**From:** [Out of Scope]  
**Sent:** Monday, 12 April 2021 2:43 PM  
**To:** [Out of Scope] Midland Highway Final Stage  
**Cc:**  
**Subject:** Comments on revised reference design  
**Attachments:** MHFS\_NORTH RRD\_COMMENT REGISTER\_MARCH 2021.XLSX; Comments Register Oatlands and Ross Revised Reference Design - Midland High~sign consultant Jacobs reference MHFS\_SOUTH RRD\_COMMENT REGISTER\_MARCH 2021.XLSX; RE: Comments register spreadsheet for Oatlands and Ross Revised Reference Designs - Southern package - Midland Highway Final Stage - Traffic engineering; RE: Comments register spreadsheet for Campbell Town to Epping Forest Revised Reference Designs - Northern package - Midland Highway Final Stage - Traffic engineering

Attached for your distribution and review are the comments on the revised reference design, which have been provided by [Out of Scope], the EDA team [Out of Scope] and [Out of Scope]

Also see attached mark-ups which provide some additional information on the general arrangement sheets and all the comments for the signs and pavement marking drawings.

Attached for your review/awareness is an updated concept design (i.e. revised reference design) for the Out of

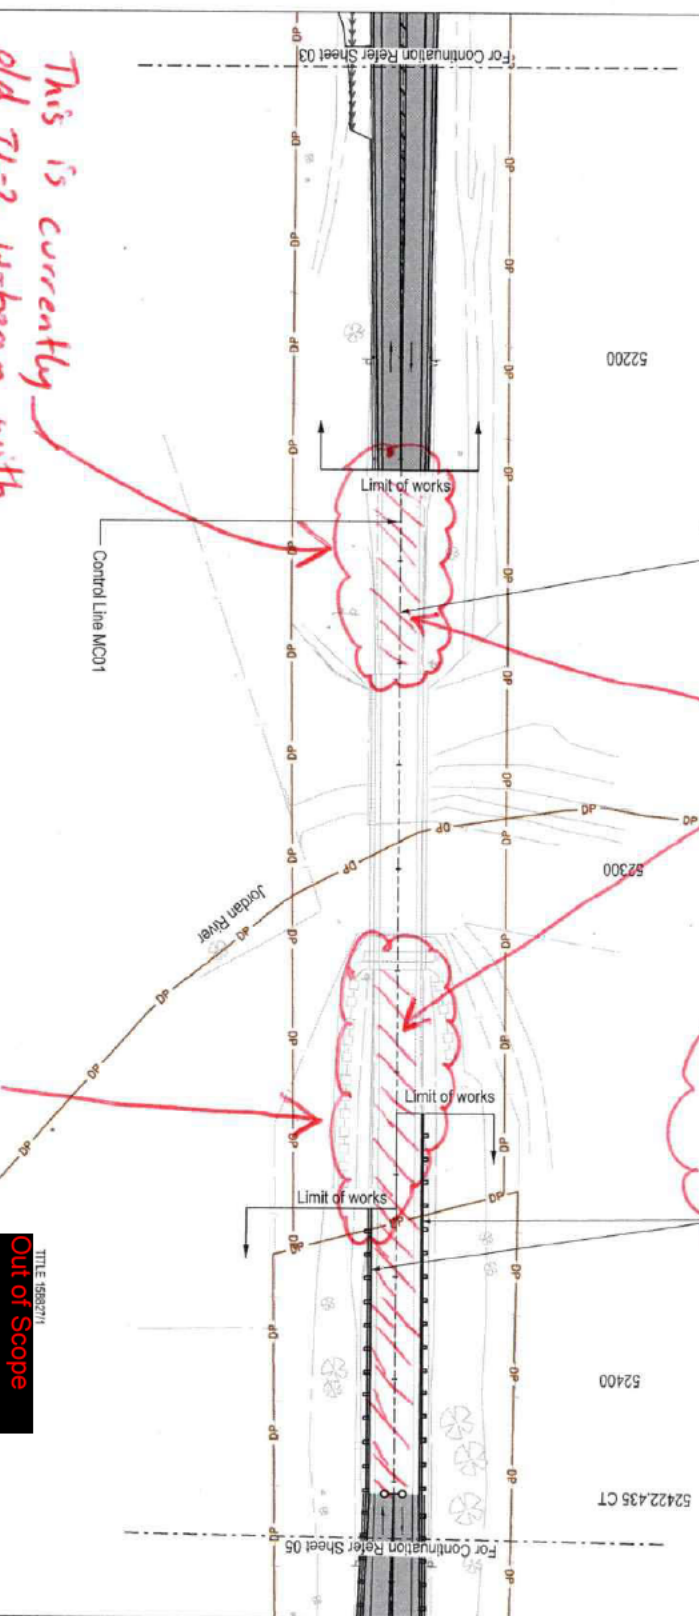
Expect shaded areas to be resealed to bridge. Is this the case?

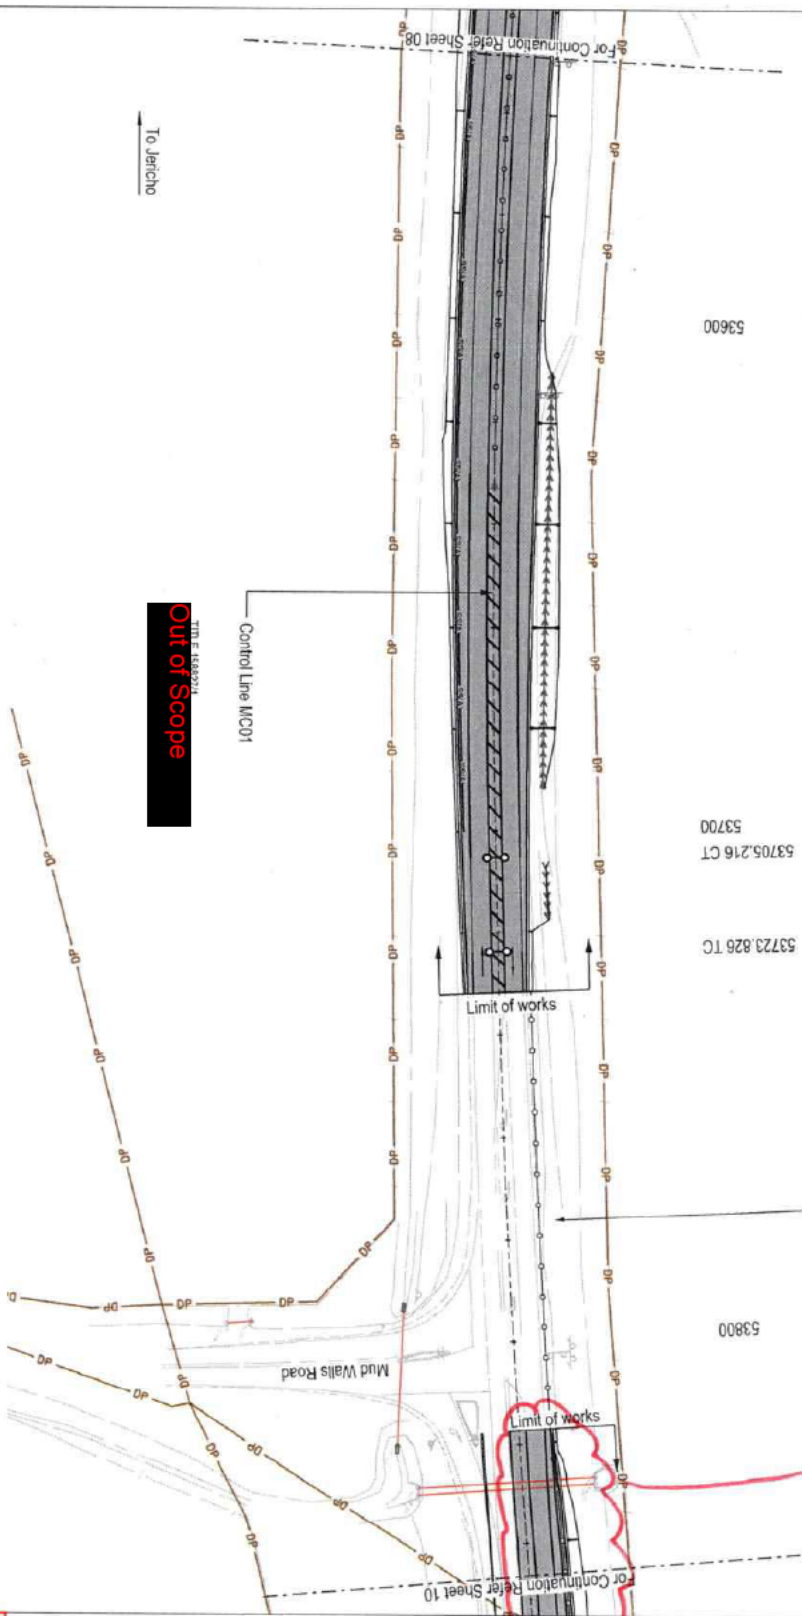
See comment  
on 1310

CONTRACT No.	3189	DRAWING NO.	ISS25316-0A1-3000-CR-DRG-1309	PRINTED DATE	3/9/2021	SHEET No.	1309
REVISION NUMBER	A0087.XXX	REVISION	2A

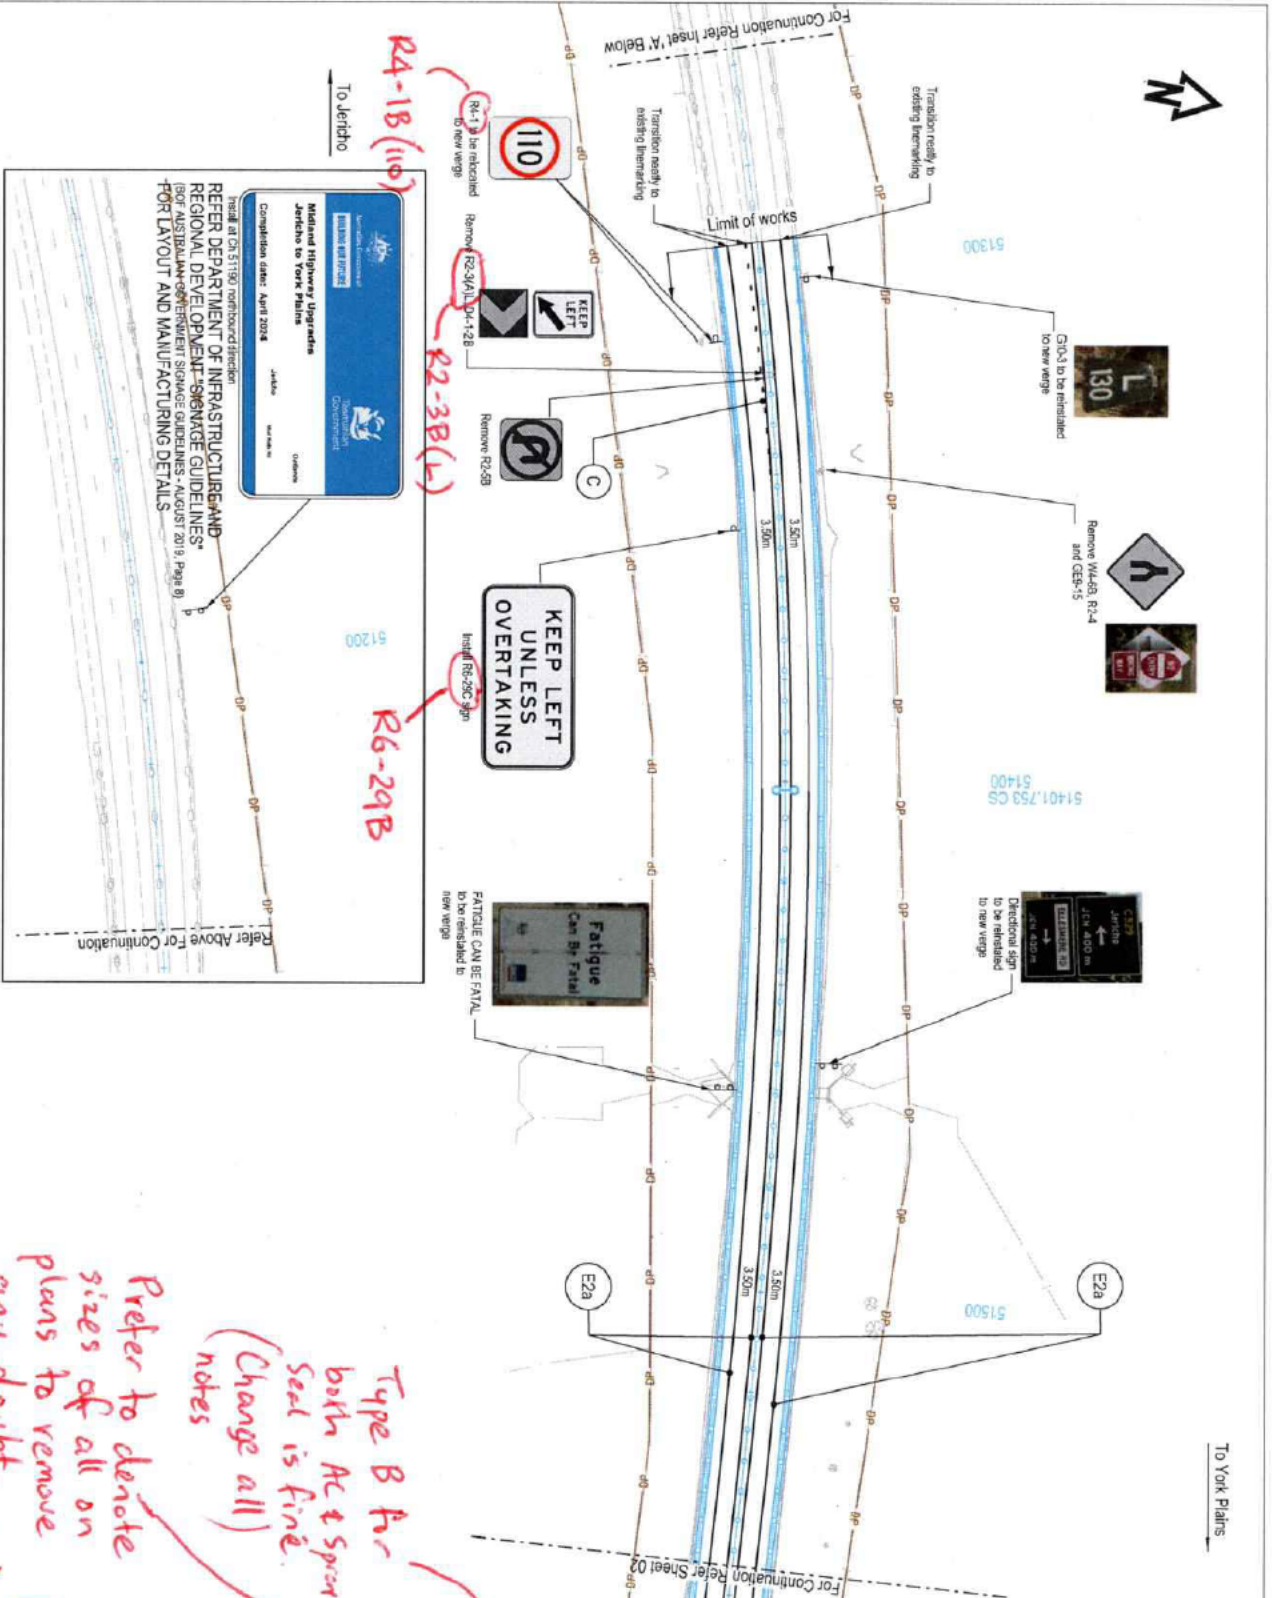
**Prefer to denote sizes of all on plans to remove any doubt. (Change all) notes**

CONTRACT NO.	3169	PRINTED DATE	3/9/2021	SHEET NO.	4804
DRAWING NO.	IS282319-0A1-3000-CR-DRC-G4014	REGISTRATION NUMBER	A0087.XXX	REVISION	2A

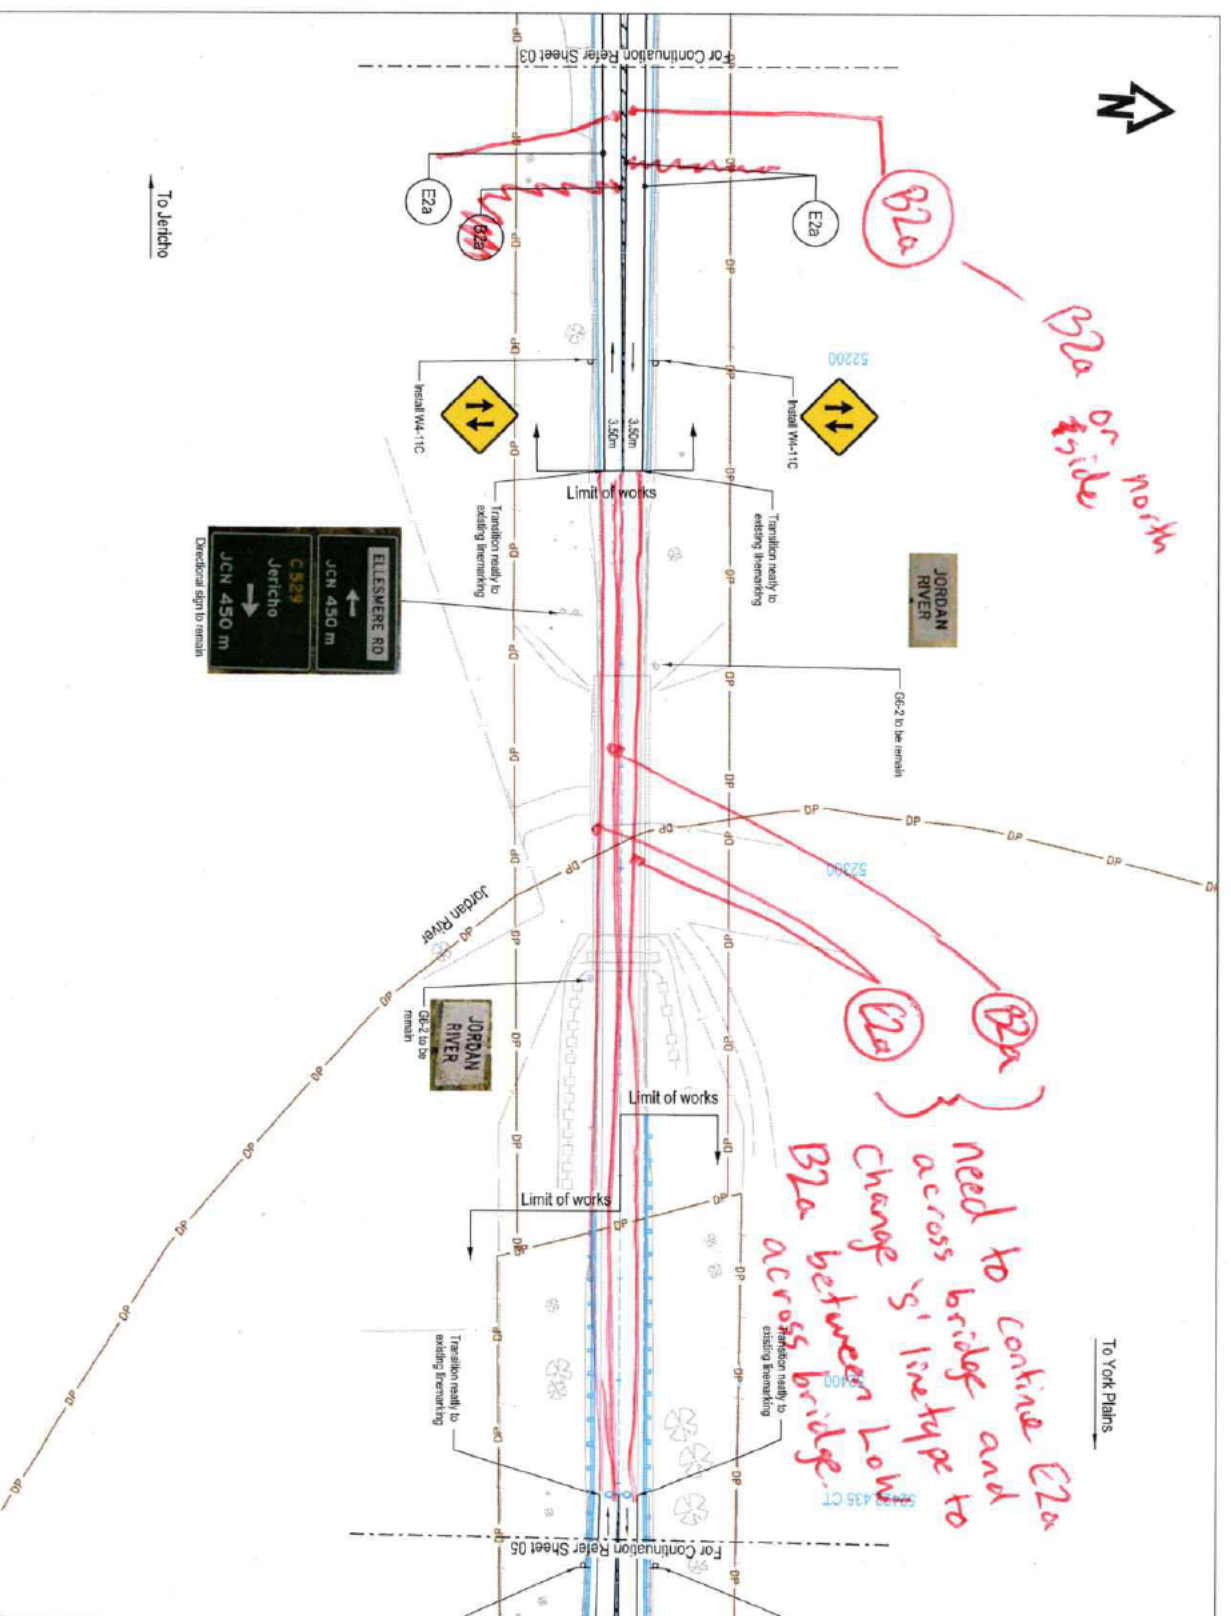
need to continue E2a across bridge and change sign type to B2a between Low B2a across bridge.
